**Architectural Review Board Meeting Agenda**  
**Monday, February 9, 2026, 4:00PM Norfolk**  
**City Hall, 810 Union Street, 11<sup>th</sup> Floor**

## #26-00356 Certificate of Appropriateness Report

## #26-00358 Certificate of Appropriateness Report

## #26-00349 Determination of Architectural Appropriateness Report

Window L.

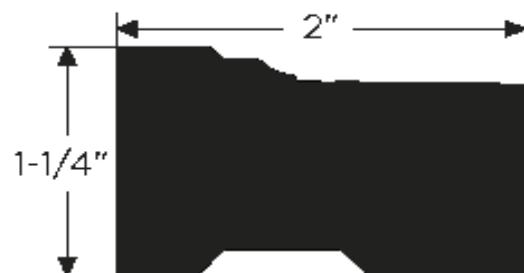
Window A – Brick moulding has minor water damage on both sides.

Window B –Brick moulding has damage at bottom left side.

Window G –Brick moulding is extensively deteriorated underneath both windows.

Window H –Brick molding has damage on both sides at bottom.

Window M –Brick moulding has minor deterioration at bottom left side.

Google Streetview of previous fence.

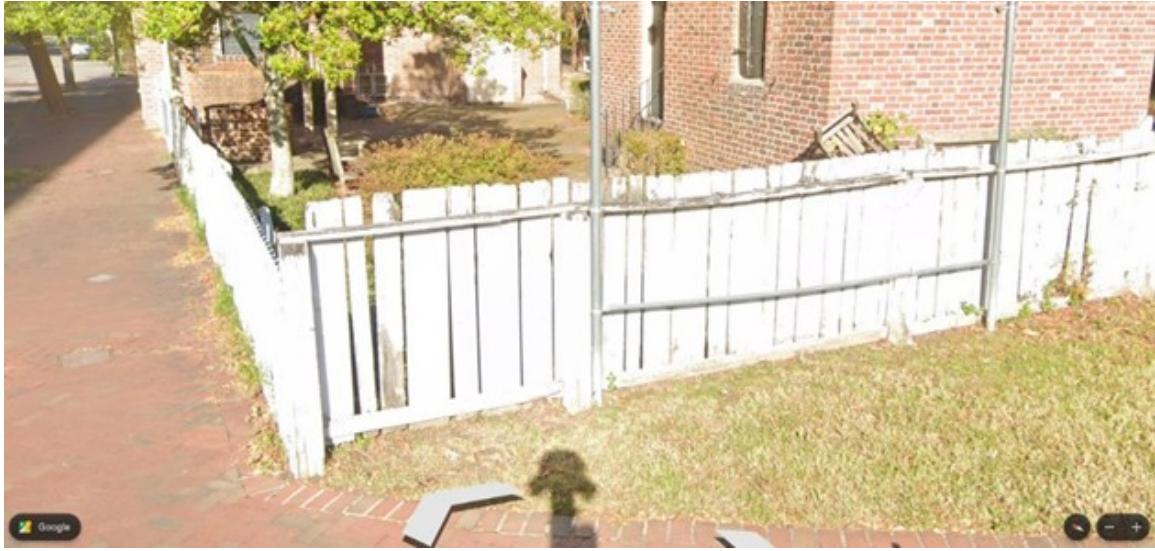
The previous fence along the rear property line was non-conforming, and the wood fence installed without a Certificate of Appropriateness or Zoning Certificate also does not comply with the development standards outlined in Section 5.11.6.A of the Zoning Ordinance.

These standards include requirements for transparency, height, and design. The applicant proposed a new fence constructed with 1x6 boards cut to match the height of the existing picket fence along Cumberland Street, with six-inch gaps to meet the 50% transparency requirement. The fence will also include 2x4 crossbars attached to the existing posts, which will be cut and reused. The fence will be painted white to match the existing picket fence.

1. The fence shall be rotated so that the finished side faces outward.
2. The fence height and transparency shall comply with the Zoning Ordinance requirements.

Dimensions of mini-split, distance from property line, and mounting height from the ground.

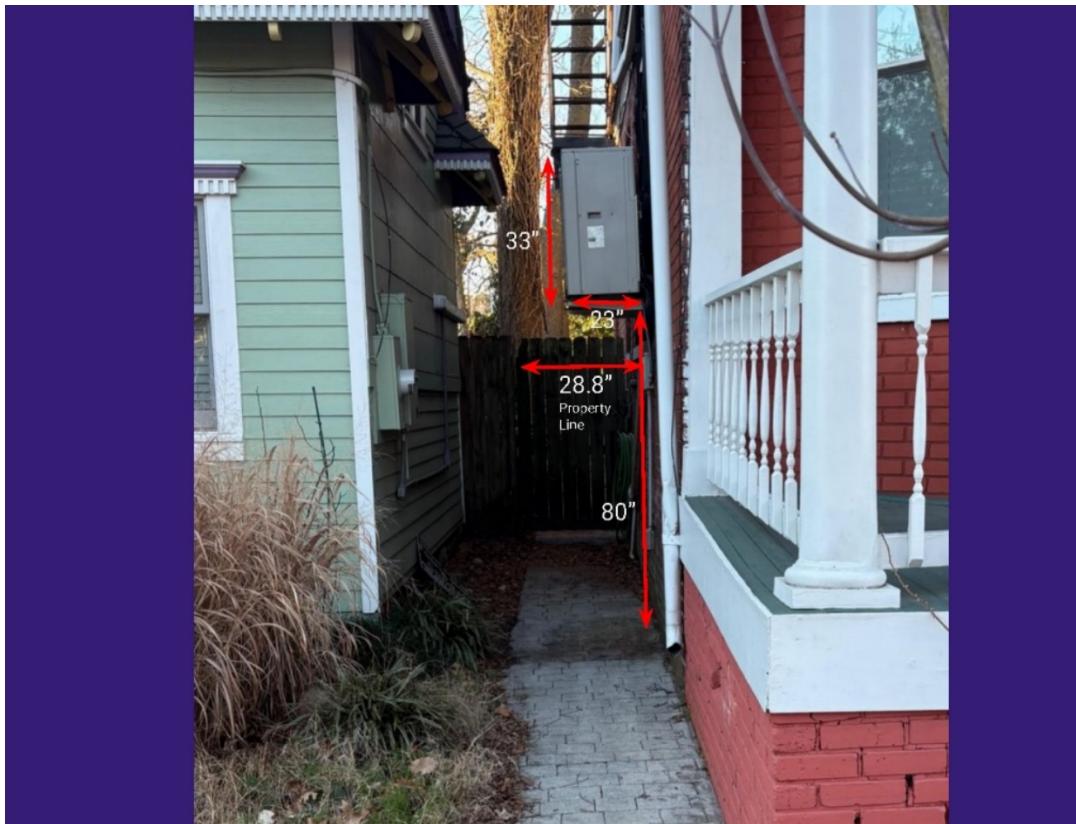
1. The mini split unit and conduit lines are highly visible from the public right-of-way.
2. The mini split unit is located within the setback, and proposed screening solution would also be located within the setback, further exacerbating the issue.
3. Mounting brackets penetrate the brick, and multiple additional penetrations exist in the exterior walls for conduit lines.
4. Some of the proposed screening solutions include artificial greenery.

The existing mini split, installed by a previous owner, is prominently visible, including the exposed conduits to the upper story. The guidelines for mechanical, electrical and other utility equipment state that units should be located inconspicuously and installed to minimize harm or alteration to historic buildings. As installed and as the unit would be retained, the mini-split system results in multiple penetrations into the building: mounting into the brick and conduit lines into the shingle siding on the upper story. This does not meet the guideline requirement to minimize harm to the building. Multiple penetrations like

Staff recommends denial of this application.

Survey of 511 Boissevain Avenue completed February 5, 2025; annotated by applicant with location of mini split.

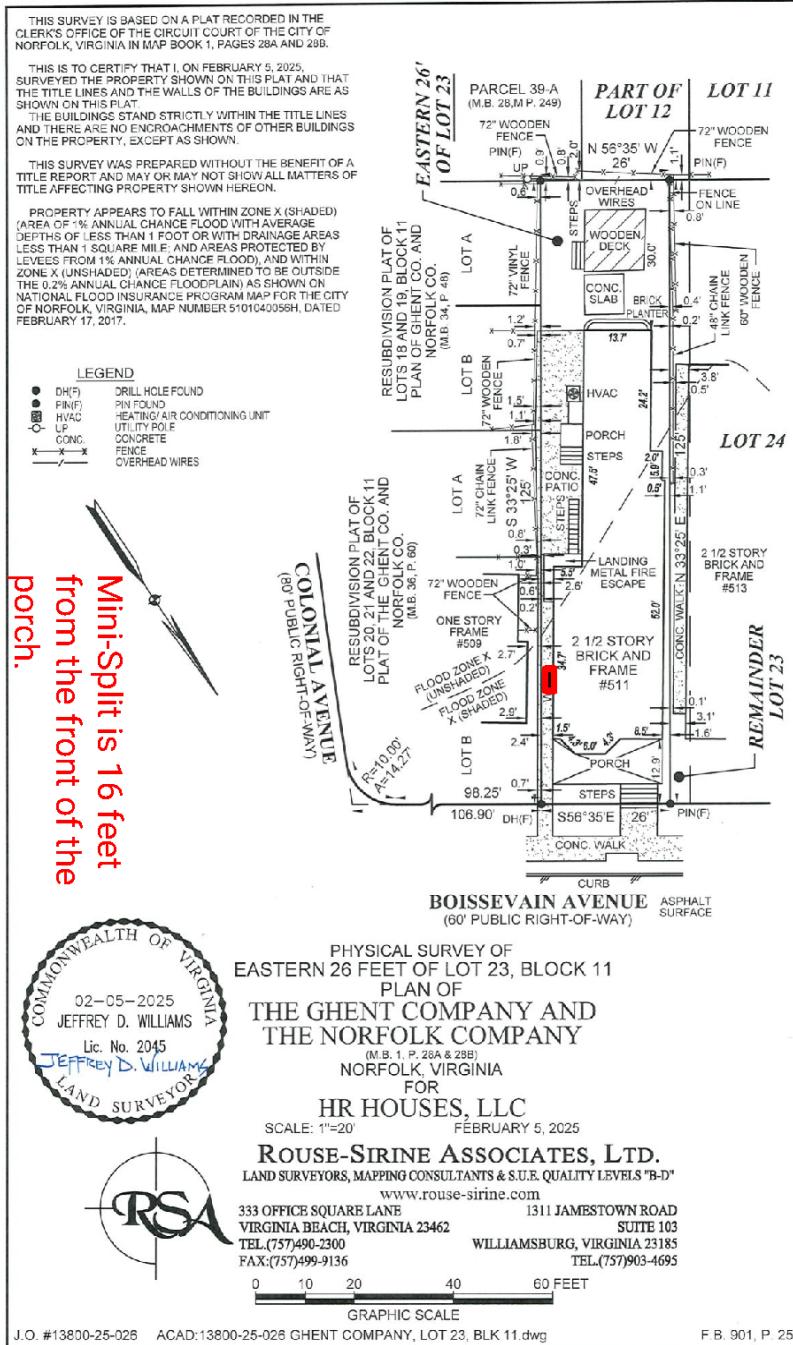
While the guidelines recommend screening or landscaping when appropriate, adding screening in this case would introduce an additional element in the setback, adding to the setback encroachment rather than alleviating it. The proposed wood trellis screening option is similar to gates and fences. The guidelines for fences recommend that new fences be consistent with others in the neighborhood and constructed of materials predominant in the district. On the 500 block of Boissevain Avenue, the predominant material for gates and fences is wood, typically solid wood privacy fences. The proposed wood trellis would be generally consistent with the existing gates and fences located on the side elevations that provide access to rear yards, though there will be some visibility of the unit from the side as the trellis is proposed only across the front of the unit.

Screening proposal: Wood lattice trellis extending to the ground.

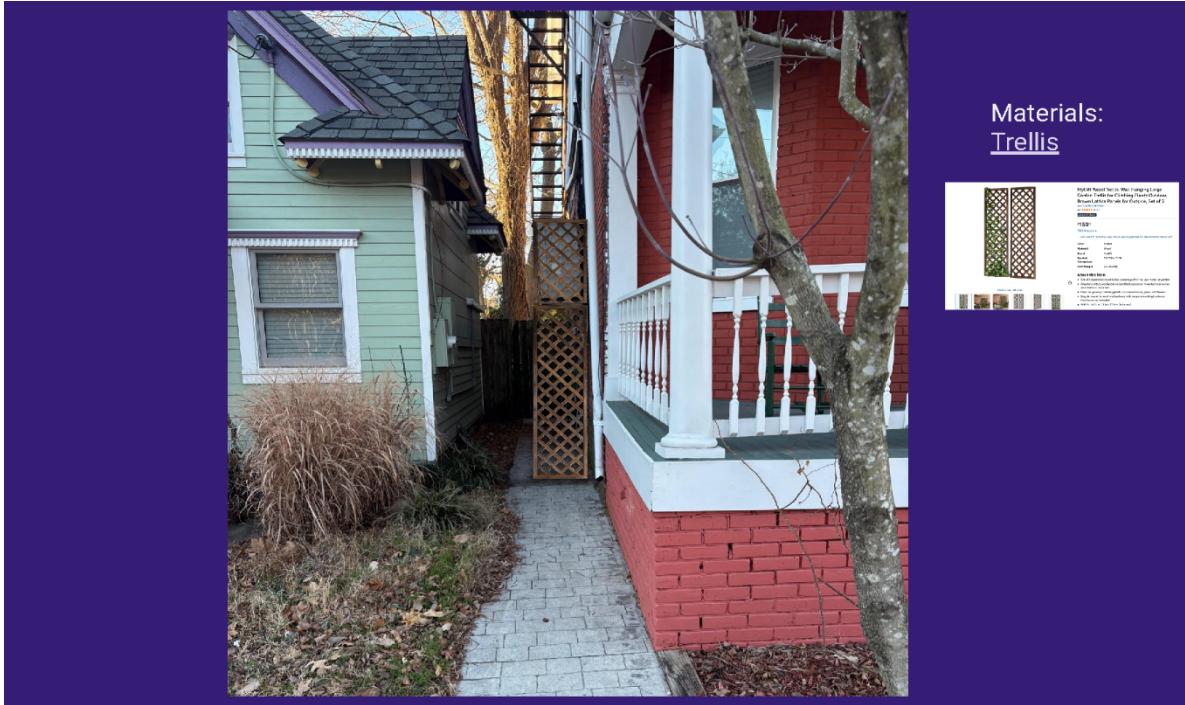
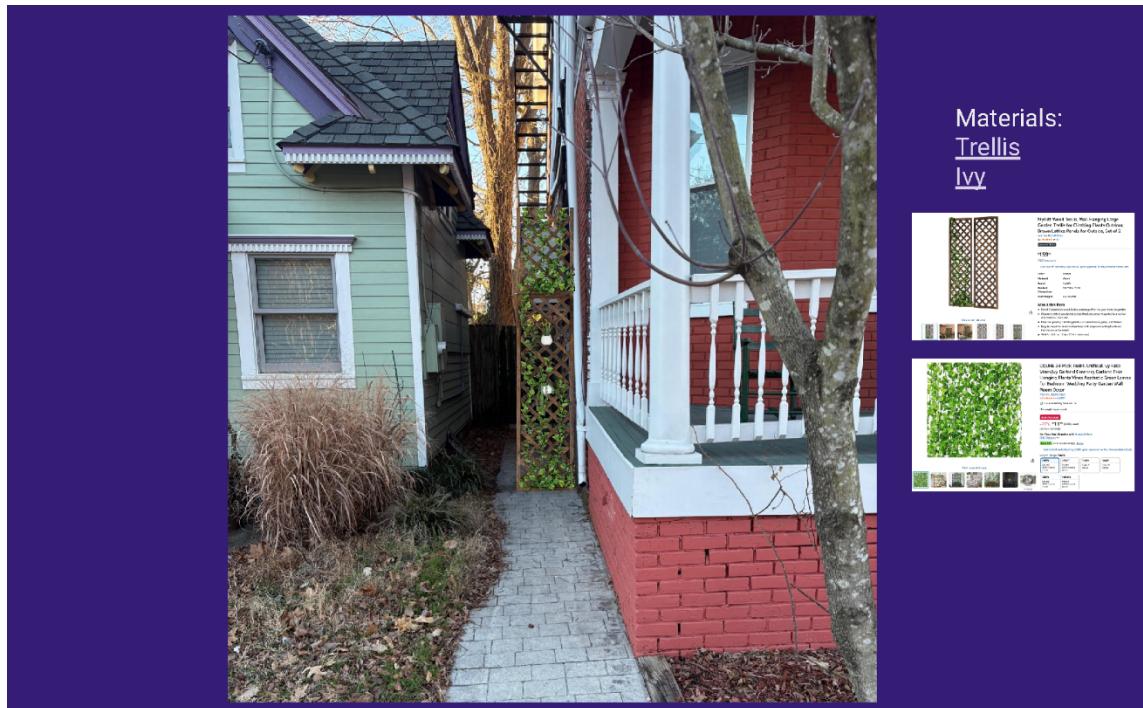
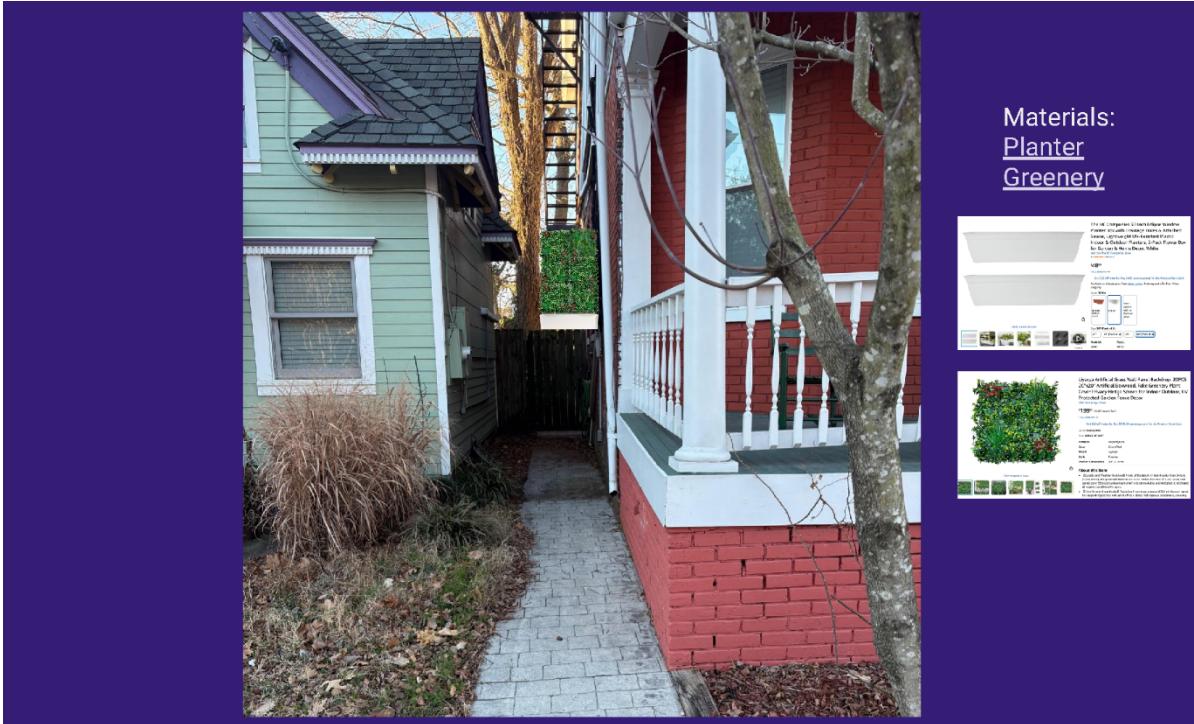
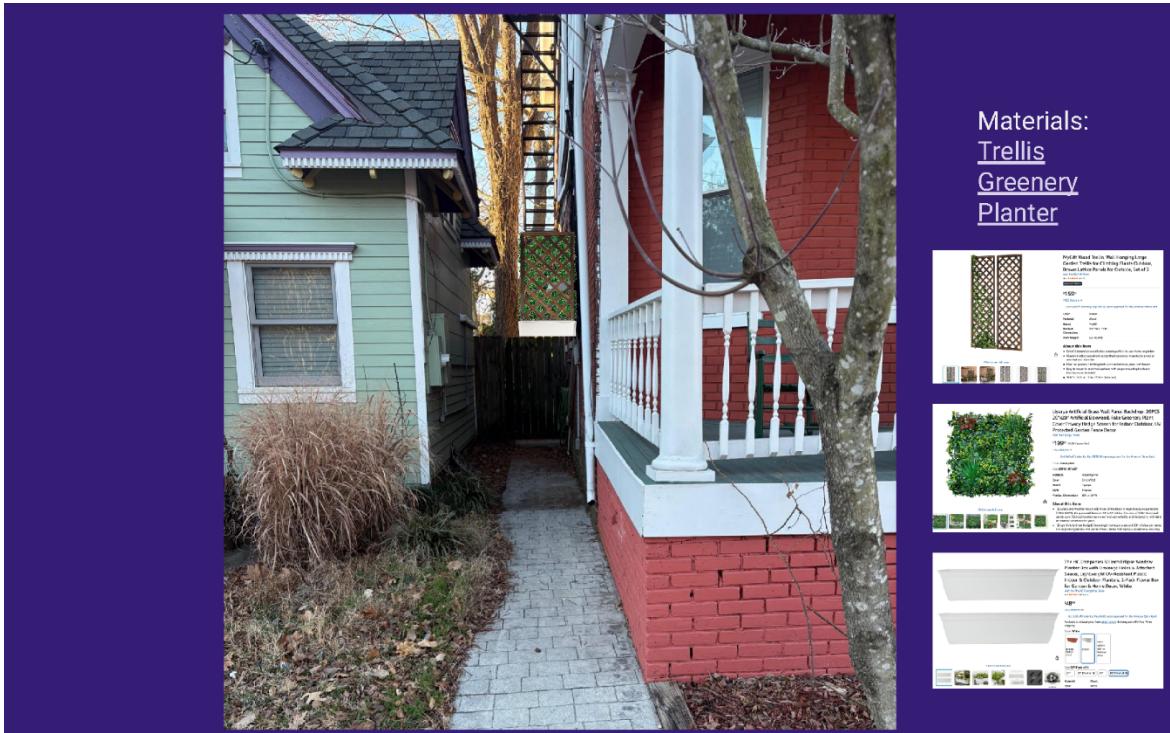
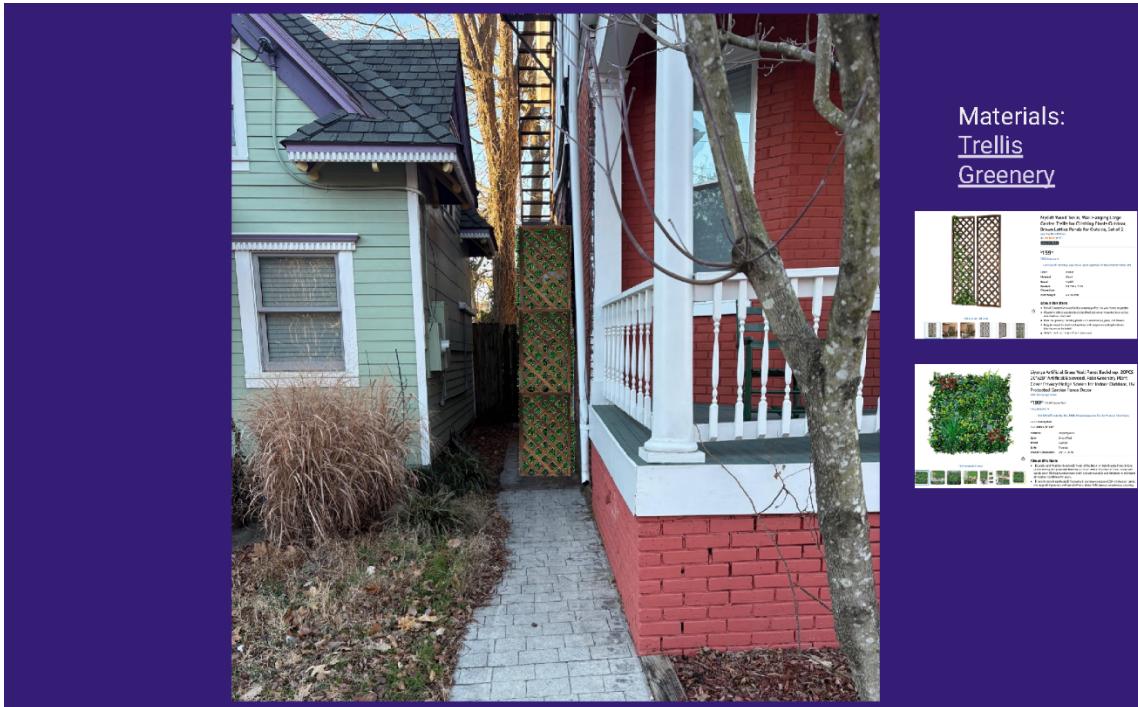
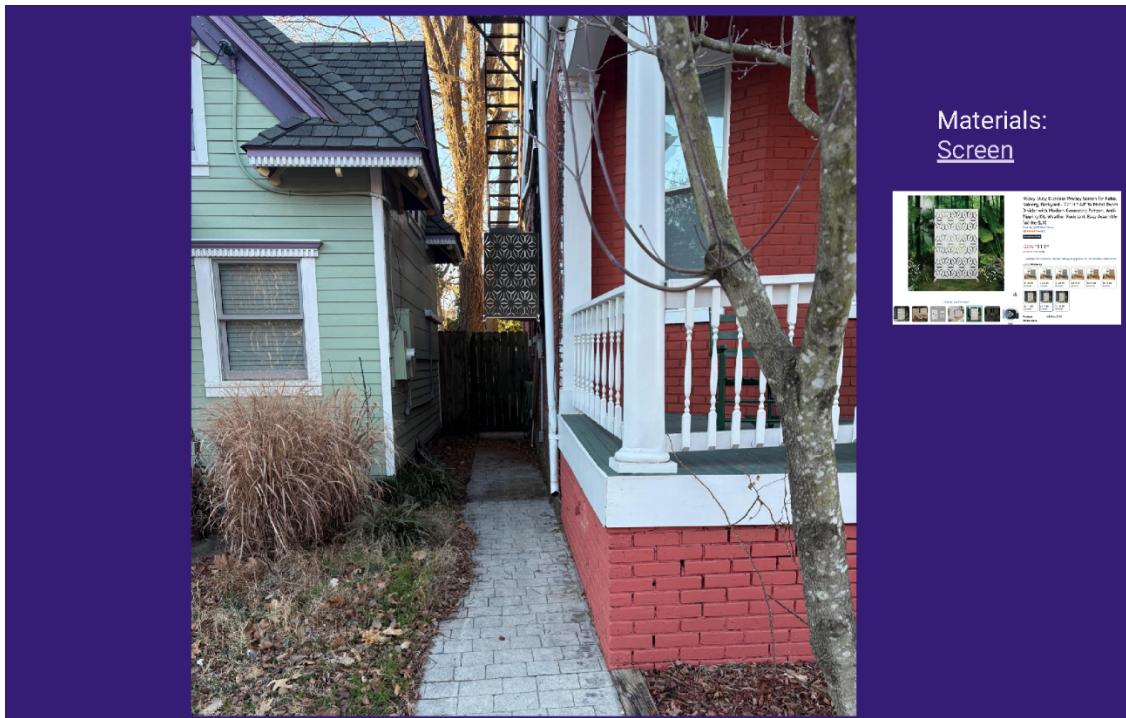
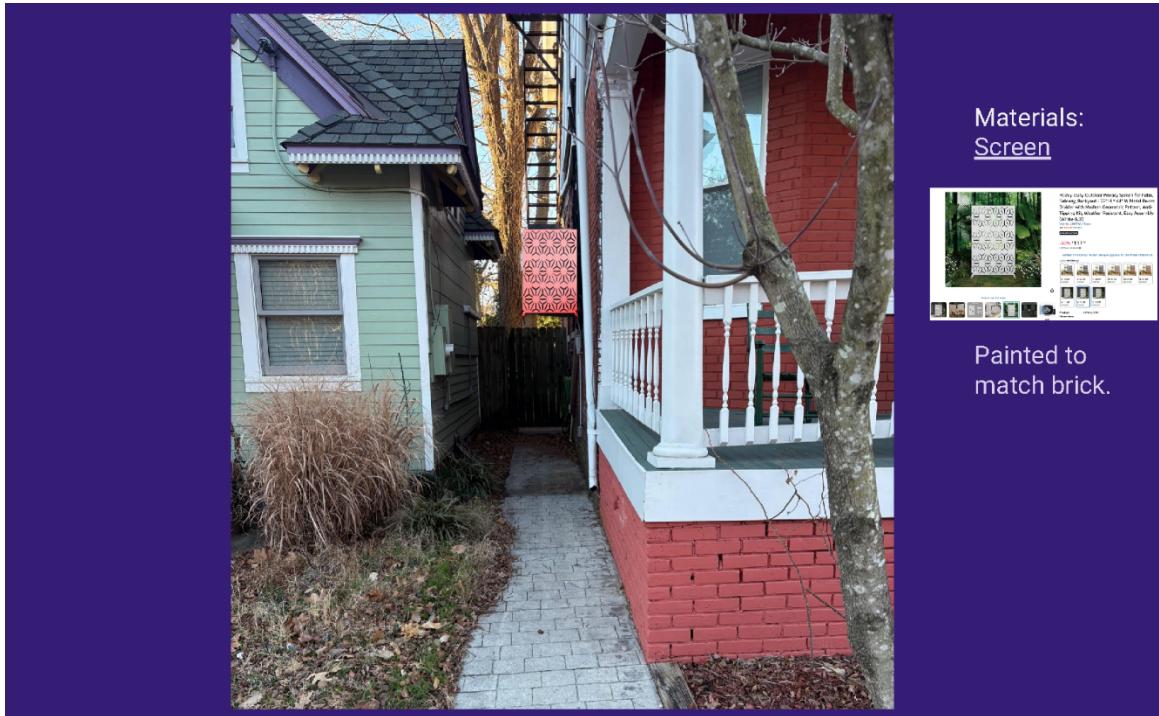
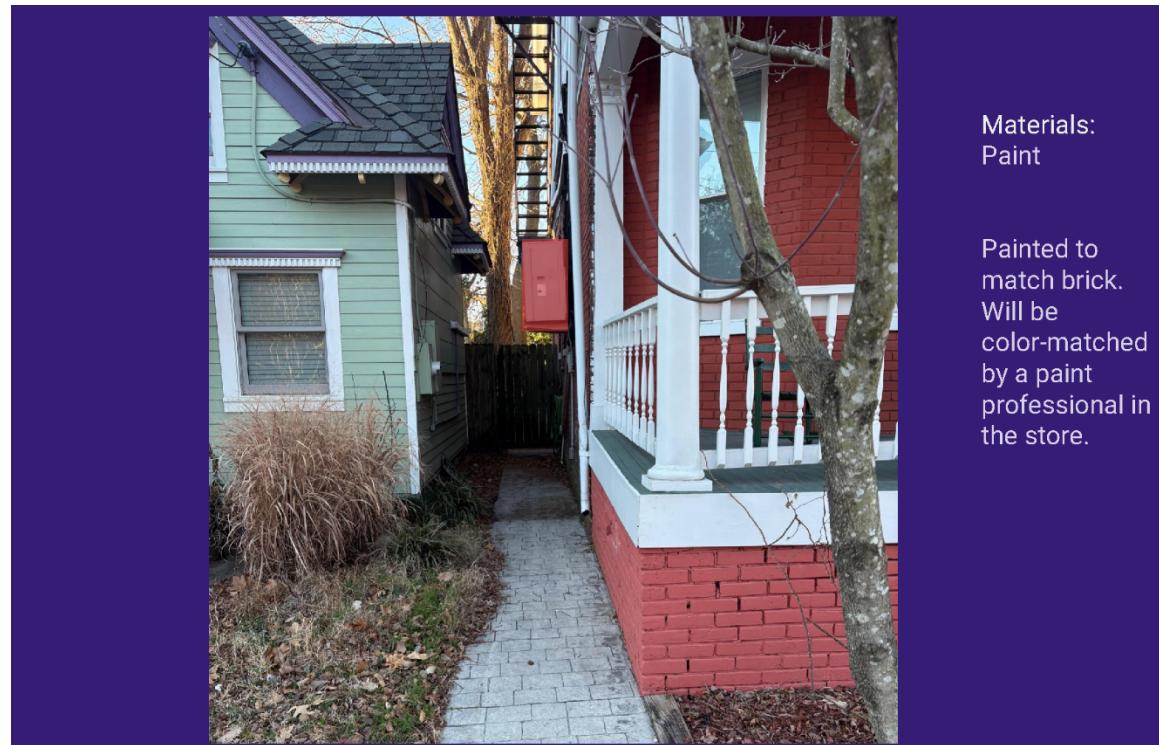
1. The trellis proposal partially mitigates direct visibility of the unit from certain angles but is less effective than if the unit was relocated to the rear.
2. The proposal to paint the unit and conduits aligns with the guidelines and follows the same mitigation used for other equipment.

Google Streetview of previous fence.

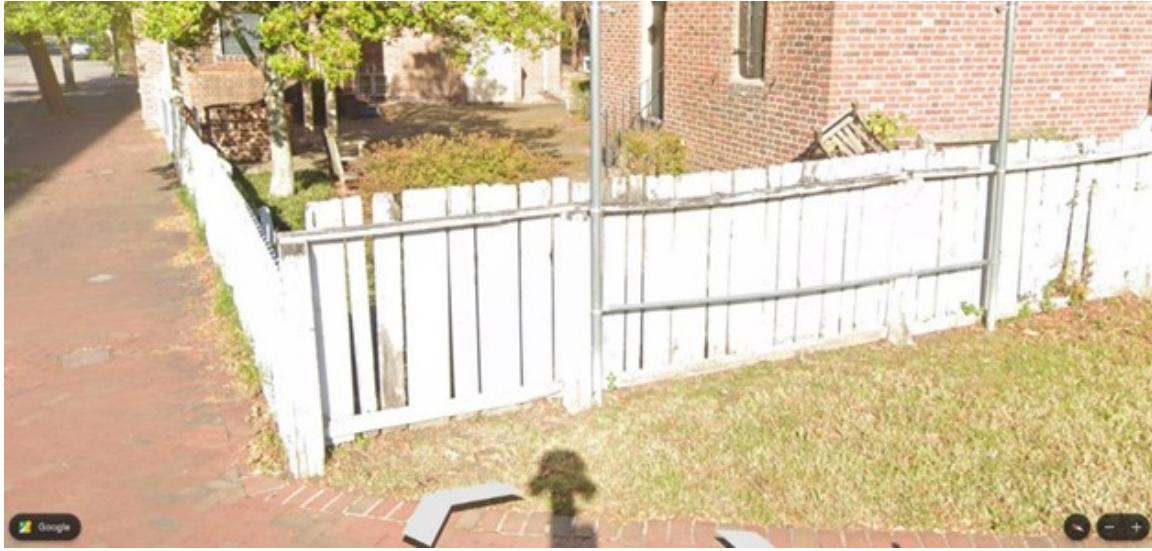
The previous fence along the rear property line was non-conforming, and the wood fence installed without a Certificate of Appropriateness or Zoning Certificate also does not comply with the development standards outlined in Section 5.11.6.A of the Zoning Ordinance. These standards include requirements for transparency, height, and design. The applicant proposed a new fence constructed with 1x6 boards cut to match the height of the existing picket fence along Cumberland Street, with six-inch gaps to meet the 50% transparency requirement. The fence will also include 2x4 crossbars attached to the existing posts, which will be cut and reused. The fence will be painted white to match the existing picket fence.

1. The fence shall be rotated so that the finished side faces outward.
2. The fence height and transparency shall comply with the Zoning Ordinance requirements.
